**City of Leawood
Planning Commission Agenda
January 10, 2017
Dinner Session – 5:30 p.m. - No Discussion of Items
Meeting - 6:00 p.m.
Leawood City Hall Council Chambers
4800 Town Center Drive
Leawood, KS 66211
913.339.6700 x 160**

City of Leawood Planning Commission Staff Report

VILLAGE OF LEAWOOD - REQUEST FOR APPROVAL OF A REZONING FROM REC (PLANNED RECREATION) TO RP-2 (PLANNED CLUSTER DETACHED RESIDENTIAL), PRELIMINARY PLAN AND FINAL PLAN AND FINAL PLAT - Located north of 91st Street and east of High Drive - Case 113-16 **PUBLIC HEARING**

FRONT BUILDING WIDTH DEVIATION PLAN OF VILLAGE OF LEAWOOD

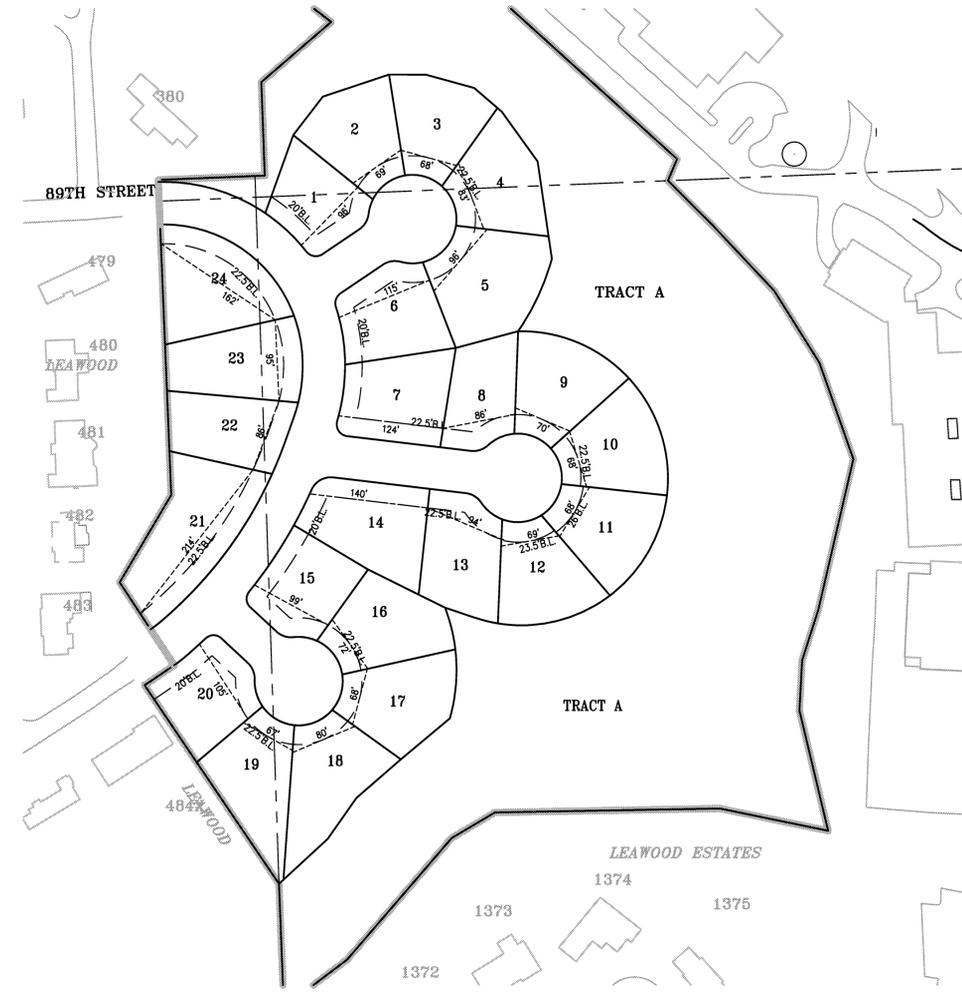
- As stated above, Rezone Tract B on the west side of Sagamore from REC to RP-2 and plat 4 new lots.
- Remove 1 lot from around the northern cul-de-sac on the east side of Sagamore, going from 7 lots to 6 lots.

- Remove 2 lots from the central cul-de-sac on the east side of Sagamore, going from 10 lots to 8 lots.
- The southern cul-de-sac on the east side of Sagamore will maintain the same number of lots as currently platted, 6 lots.

- The average size of the lots around the cul-de-sacs will increase due to the number of lots being reduced around the 2 northernmost cul-de-sacs, and the applicant proposing to increase the depth of the lots along the eastern side of the subdivision, adjacent to Tract A. As a result of increasing the lot depth of the easternmost lots around the cul-de-sacs, the applicant is proposing to remove, or reconfigure some of the existing retaining walls along the eastern side of some of the lots.

1. The project is limited to 23 single-family lots on 16.25 acres for a density of 1.42 units/acre, with a maximum of 3 single family lots west of Sagamore. Prior to Governing Body consideration, the applicant/owner will provide revised plans showing a maximum of 3 lots west of Sagamore.

LANDSCAPE PLAN OF VILLAGE OF LEAWOOD

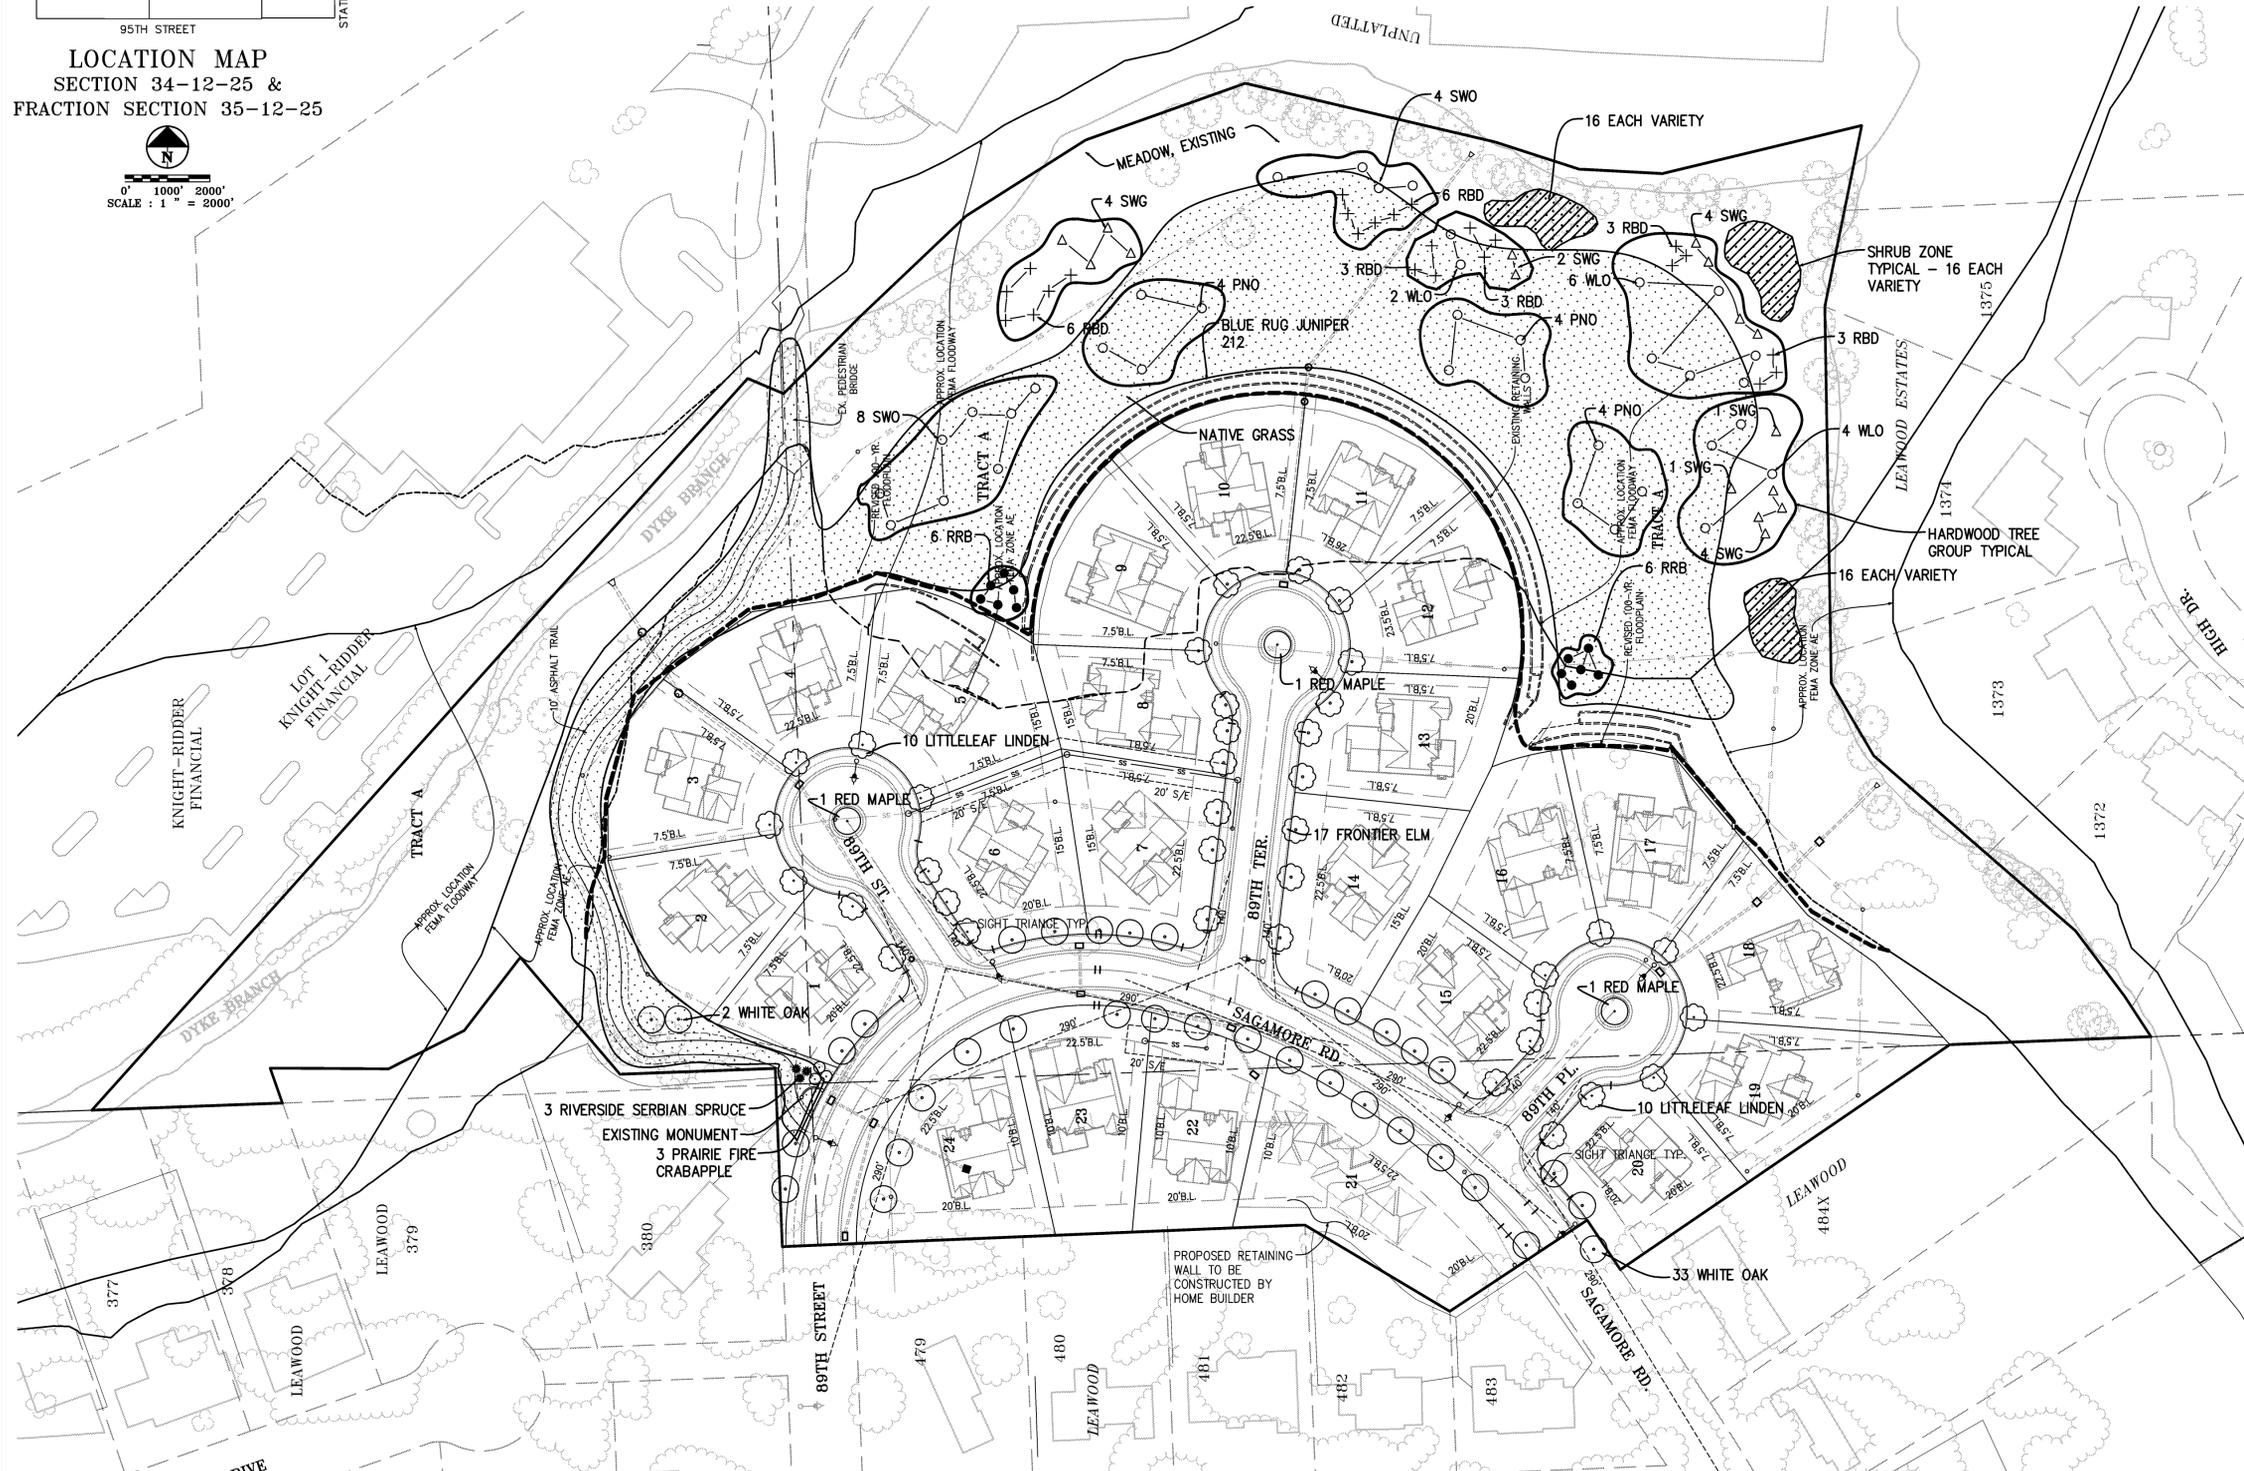
- Per section 16-4-7.2 of the Leawood Development Ordinance, street trees shall be planted at a rate of 1 street tree per 35 ft. White Oaks are proposed to be planted along Sagamore, Little Leaf Lindens are proposed to be planted around the northern and southern cul-de-sacs and Frontier Elms are proposed to be planted along the central cul-de-sac.
- Each of the 3 cul-de-sacs currently has an island that is planted with a Red Maple tree. The applicant is not proposing to irrigate the these landscaped islands.

- Section 16-4-7.3 of the Leawood Development Ordinance requires that all landscaped areas be irrigated. Each of the landscaped islands within the cul-de-sacs is planted with an existing Red Maple Tree. As these islands are formally landscaped, staff recommends that these landscaped islands be irrigated. **(Stipulation 13)**

12. All street trees shall be planted a maximum of 5 ft. from the back of sidewalk.
 13. All formal landscaped common areas, including all cul-de-sac islands shall be irrigated.
